UNITED STATES PATENT AND TRADEMARK OFFICE

10/777,097

Office Action Summary

FIG. 13

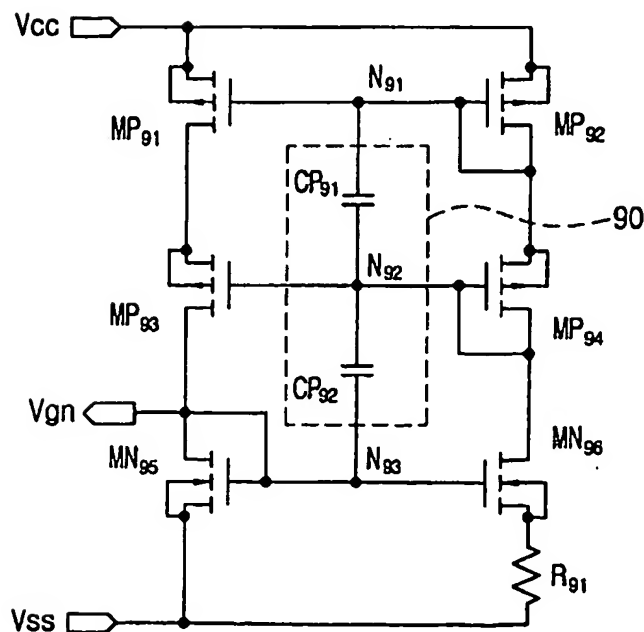
6. All 112 rejections are withdrawn in light of Applicant's amendments. The drawing amendments are also acceptable. Of course the output nodes were implied in Fig. 13 and 14. Just as they are implied in Examiner's relied upon references. Examiner is

dropping the issue of Figs. 13 and 14 so as not to clutter the present prosecution, which appears to be headed for Appeal.

Okay
to
enter
JZ
8/14/06

FIG. 14

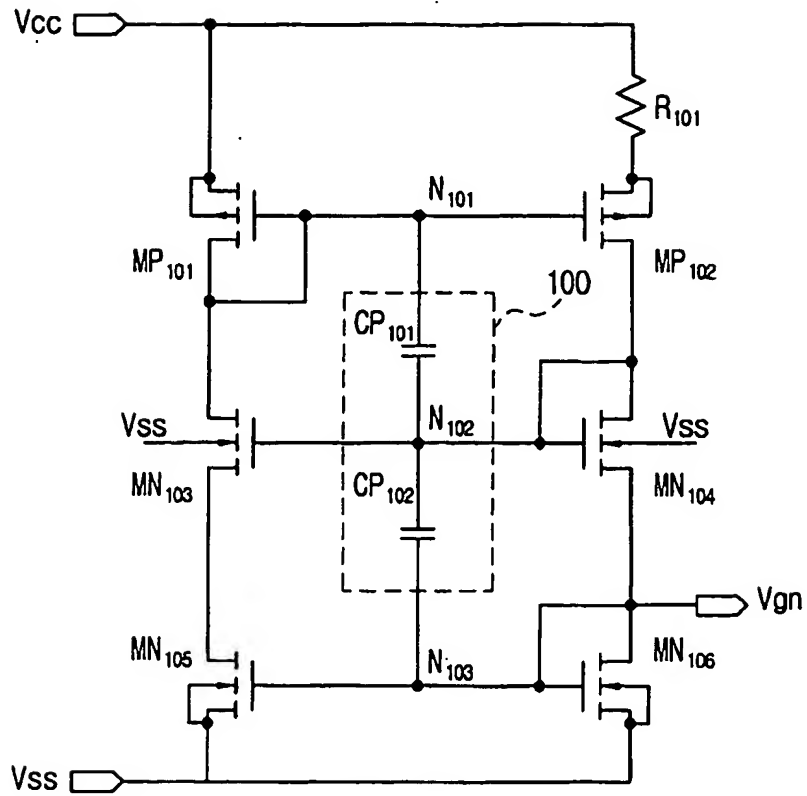
Okay
to
enter
JZ
8/14/06
